The following changes in the tender documents are effective immediately. This addendum will form part of the contract documents.

END OF ADDENDUM No. 1

FORMER HEEDE CRANE AREA INTERIM REMEDIATION PACIFIC ENVIRONMENT CENTRE SITE, WEST VANCOUVER, BC

Figure 4

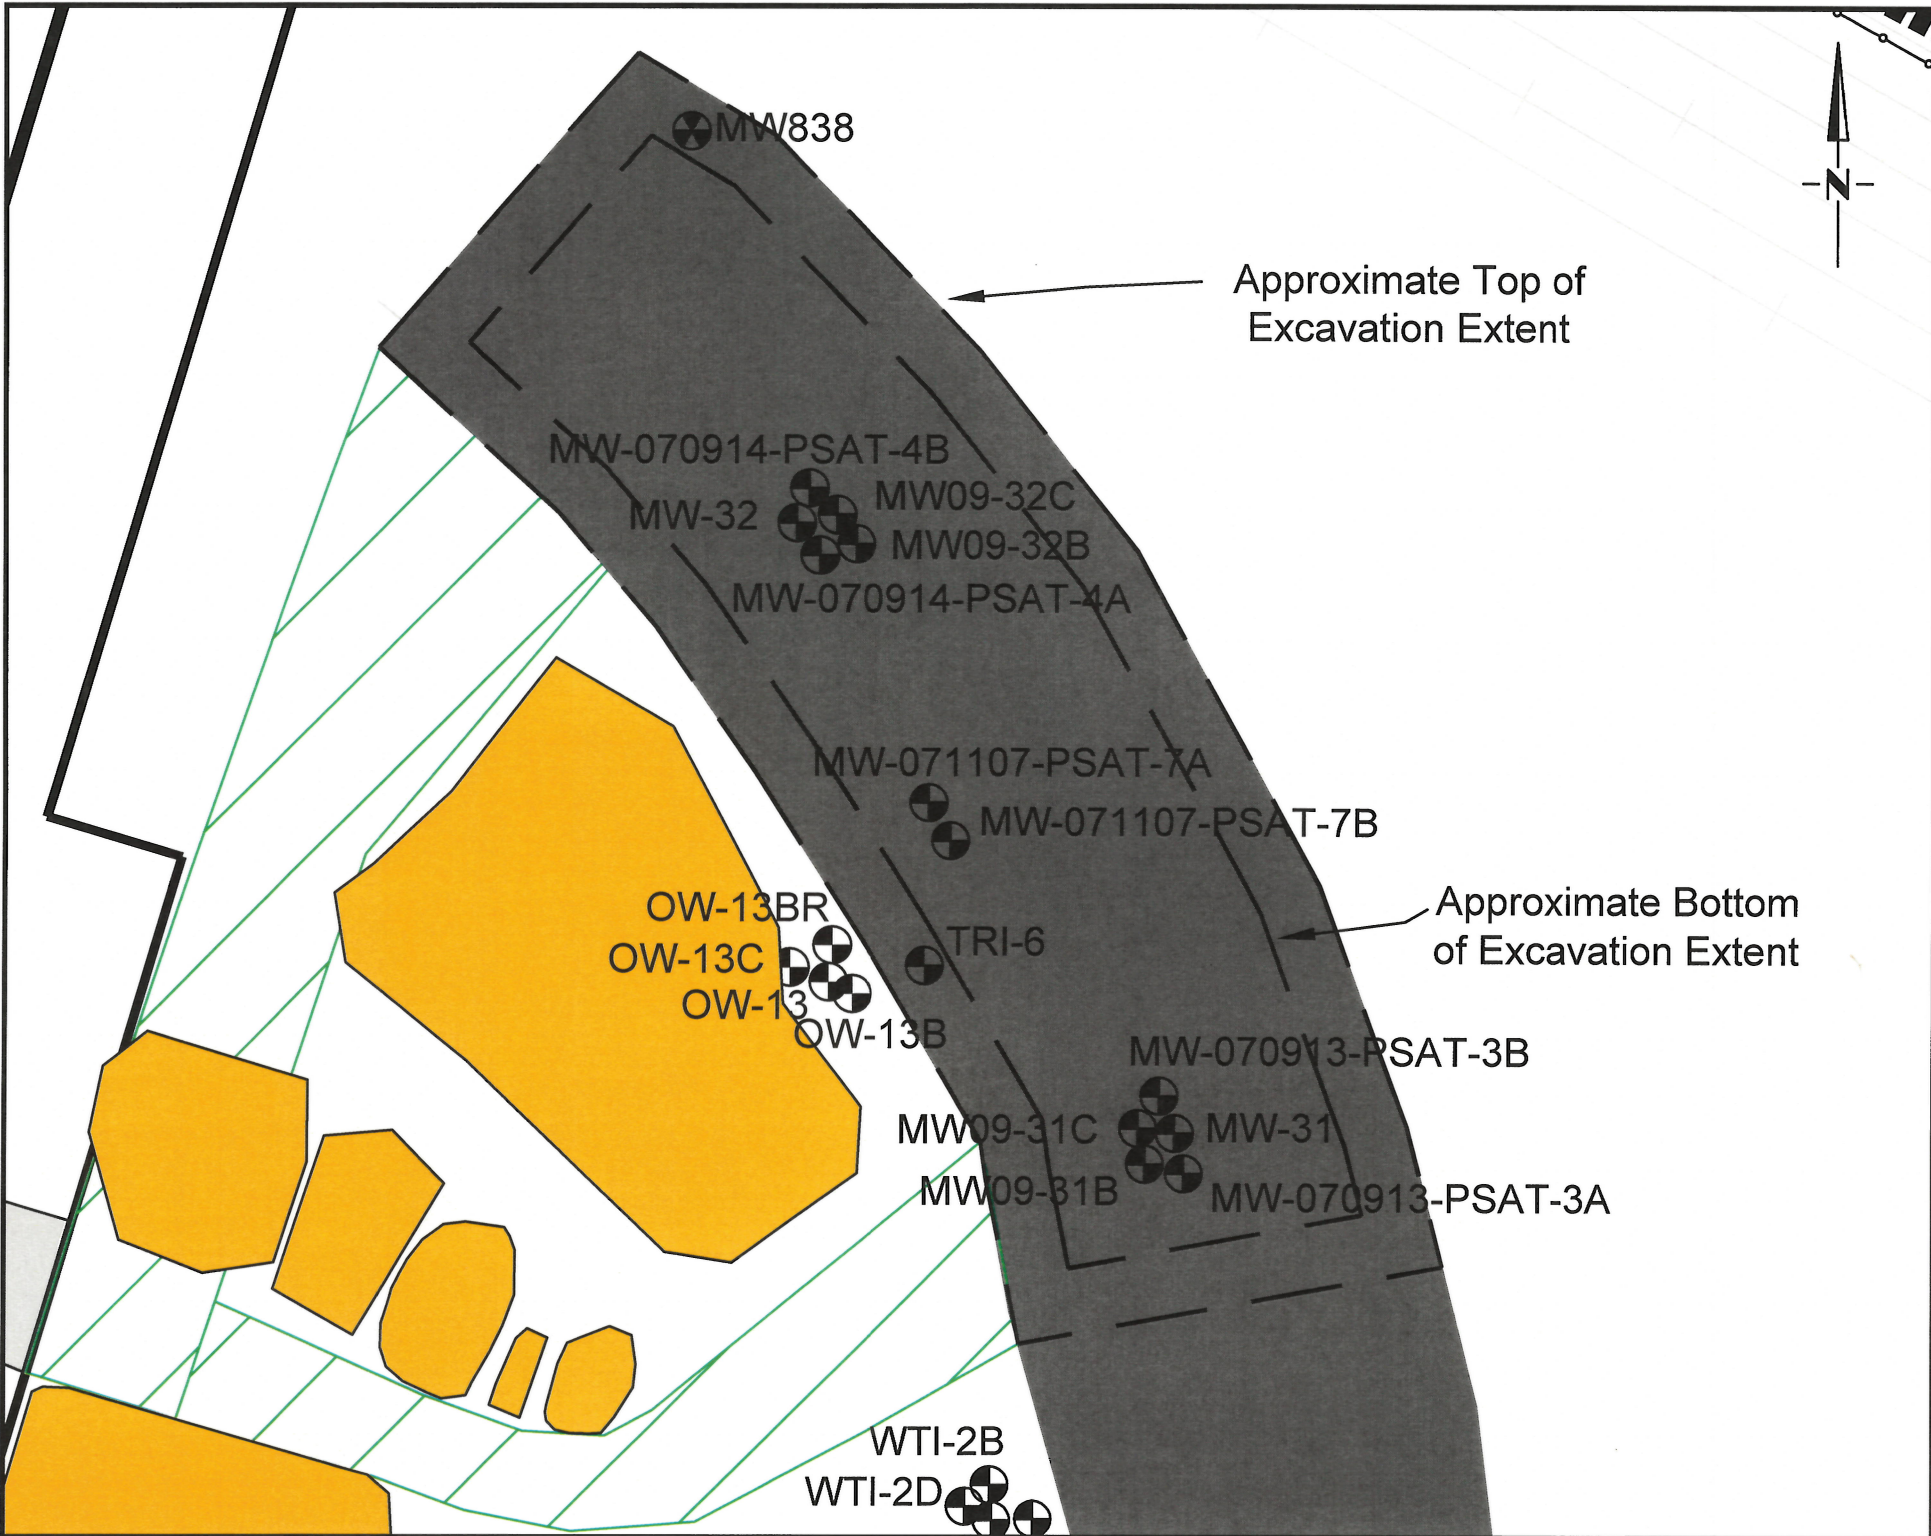
Q5**What are the holding cell dimensions in order to price liners, installation, and disposal of existing liners?****R5**

The Contractor must inspect the condition of the storage cells and repair the storage cells prior to usage. For the FY2014-15 Base Work the Contractor must remove and dispose of the existing storage cell liners and supply and install new liners. The storage cell liners shall be replaced with 30 mil LLDPE or approved equivalent. The dimensions of the storage cell liners required are:

- Cell #1: 61 x 44 m
- Cell #2: 66 x 36 m
- Cell #3: 54 x 31 m
- Cell #4: 37 x 26 m

- The storage cell liners shall be replaced with 30 mil LDPE or approved equivalent. The dimensions of the storage cell liners required are:
 - Cell #1: 61 x 44 m

- Cell #2: 66 x 36 m
 - Cell #3: 54 x 31 m
 - Cell #4: 37 x 26m
 - The liner is to extend up and over the containment berm, covering 75% of the downward slope.

Figure 7

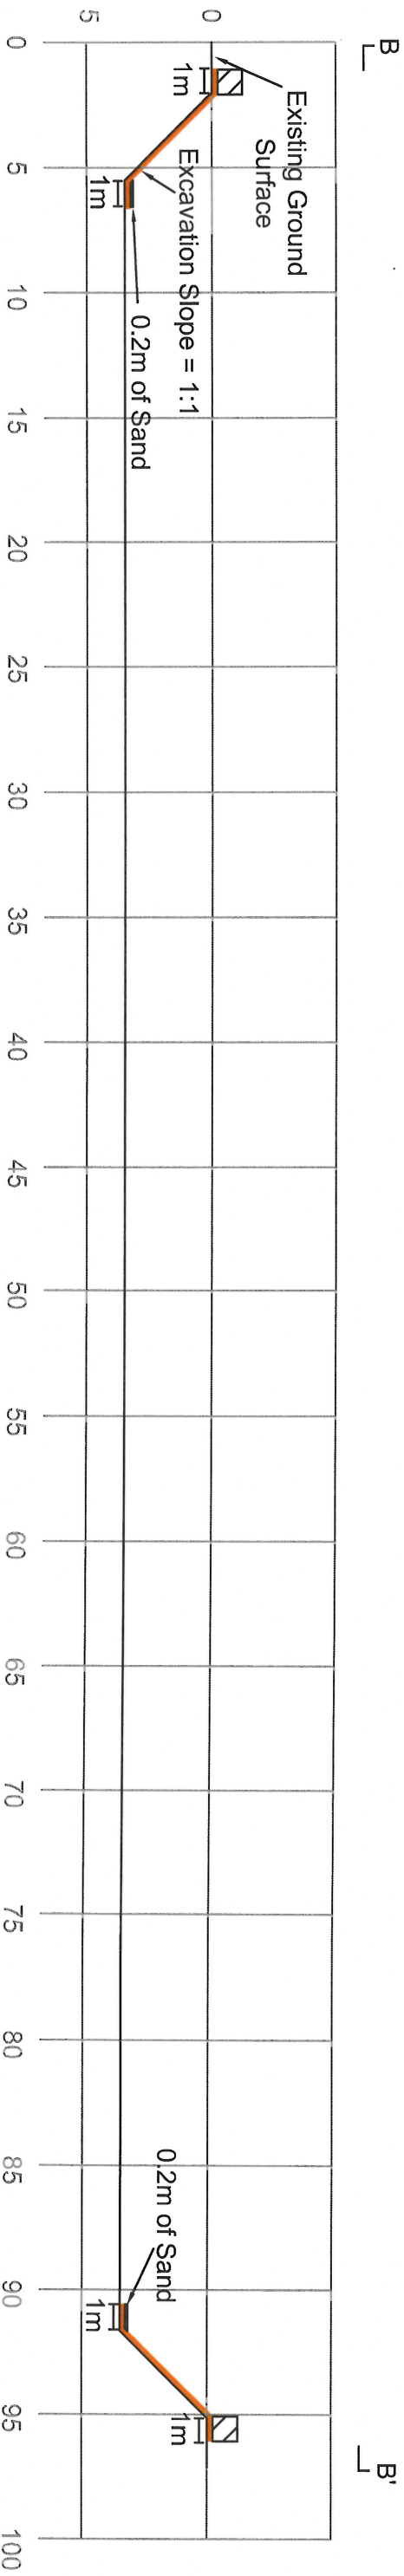
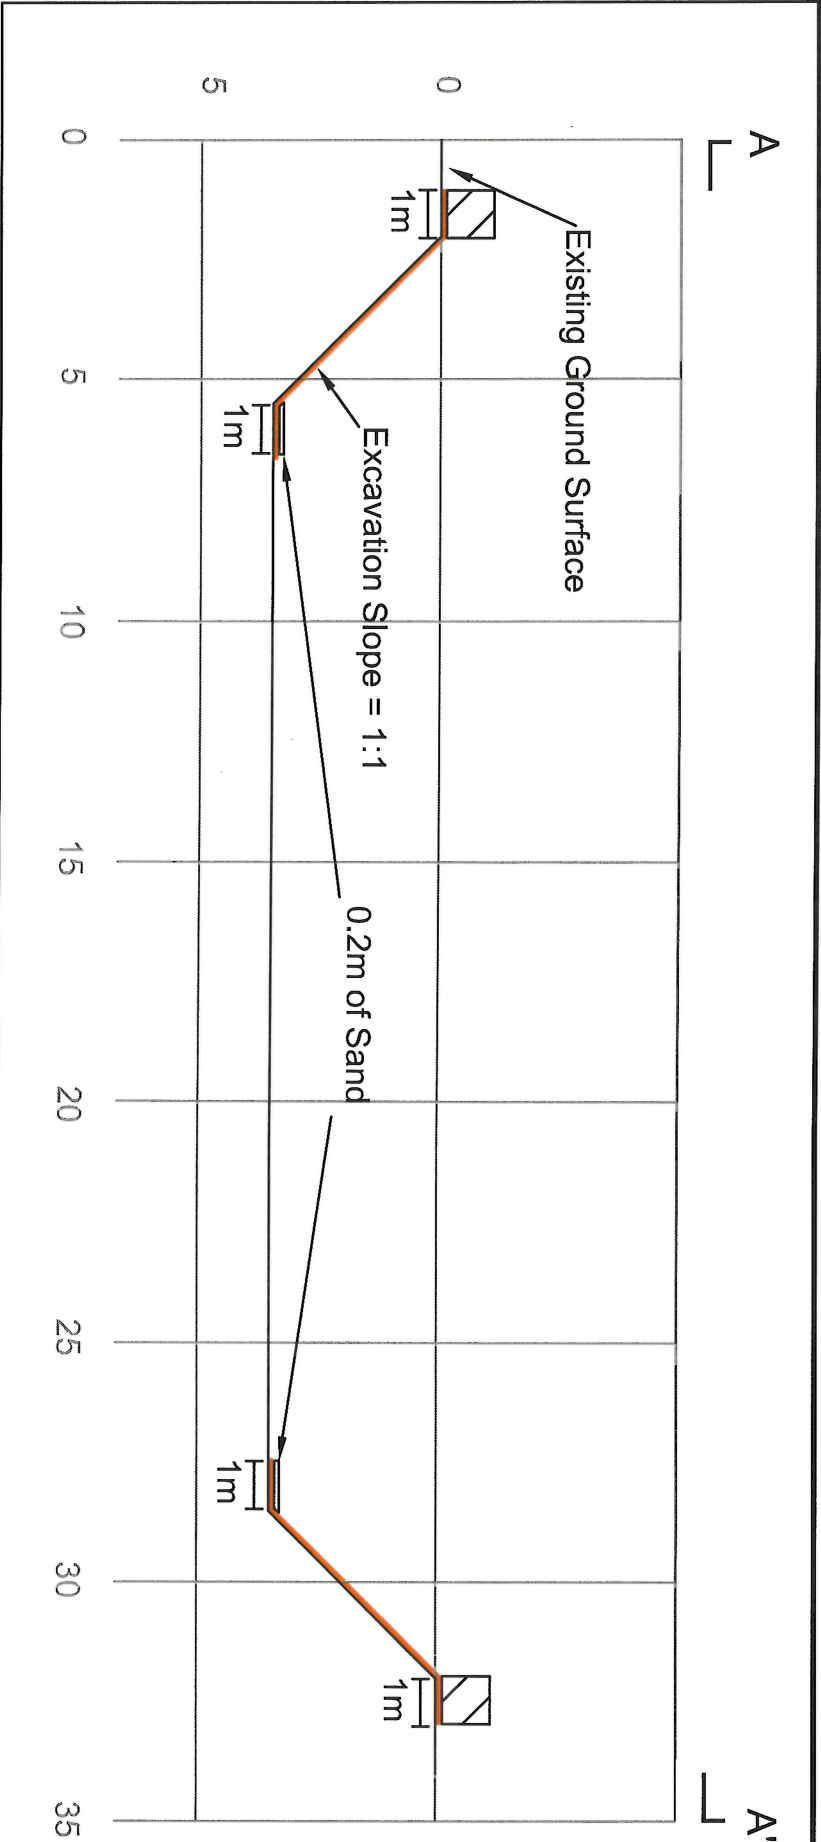
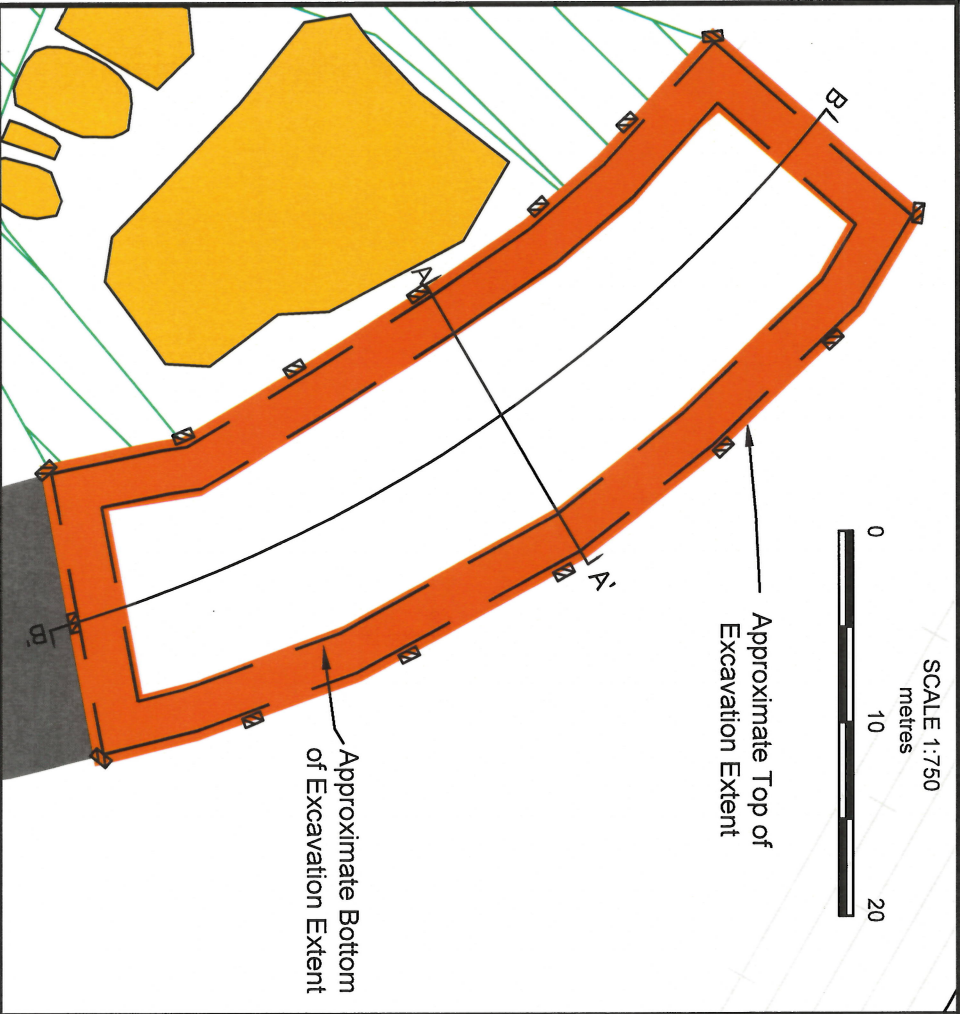
Q4**What is the Setback From Power Poles?****R4**

To protect poles within the excavations limits, there must be a 3 m setback at surface with a stable excavation slope not exceeding 1:1 from the poles.

3. Monitoring wells within the proposed excavation footprint shall be persevered. To protect poles within the excavations limits, there must be a 3 m setback at surface with a stable excavation slope not exceeding 1:1 from the poles.

Appendix 1 for Base Work (A) states Backfill Placement and compaction of 6,000 m3 of material while Figure 8 in tender documents states “the excavation will not be backfilled and the excavation walls should be protected with 20 mil LLDPE or approved equivalent.” Please confirm if the excavation is to be backfilled with the 6,000 m3 of material or if material to be stockpiled onsite for use at a later date?

Based on field conditions and as directed by the Departmental Representative, up to approximately 6,000 cubic meters of Backfill Placement and Compaction will occur as part of the Base Work. If this Work does not proceed as part of the Base Work, then all of the Backfill Placement and Compaction will occur as part of the Optional Work. This work will be paid at the unit rate for the quantity actually backfilled.

- NOTES:**
- The excavation will be backfilled up to approximately 6000 m³ as directed by the Department Representative. The excavation walls must be protected with 20 mil LLDPE or approved equivalent prior to backfilling.
 - The liner is to extend approximately 1.0 m onto the excavation floor and existing ground surface.
 - The liner must be secured by placing lock blocks (approximately 16 blocks) on the ground surface and sand or approved equivalent of approximately 0.2m thick within the excavation floor.
